1117 Hudson / Ridge Fire Damage Restoration Project

Addendum No. 1

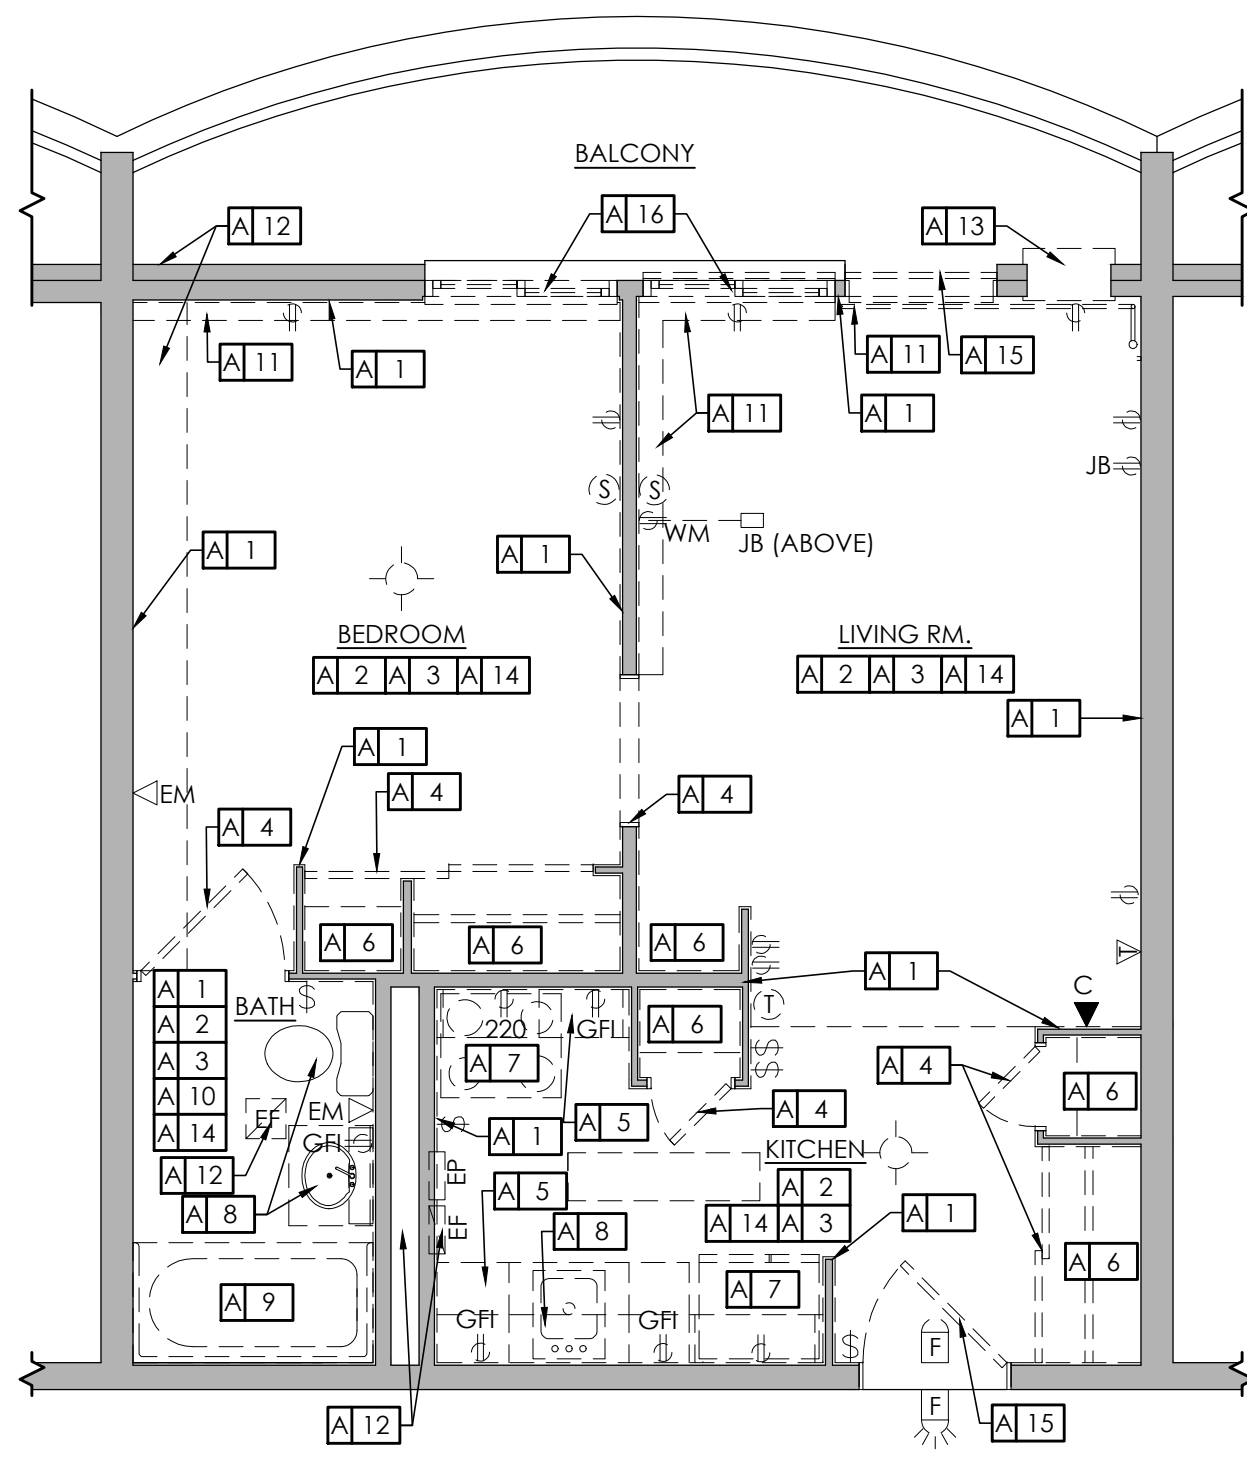
The following questions and answers apply to this contract:

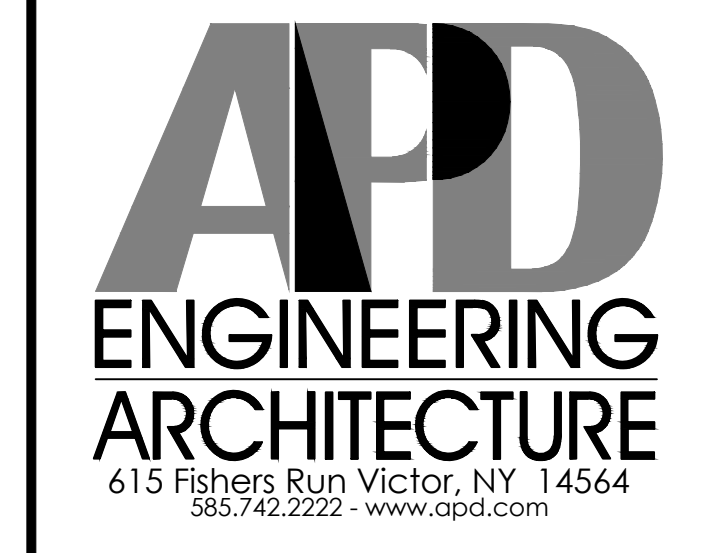
DO NOT SCALE PLANS
Copying, Printing, Software and other processes required to produce these prints can stretch or shrink the actual paper or layout. Therefore, scaling of this drawing may be inaccurate. Contact APD E&A with any need for additional dimensions or clarifications.
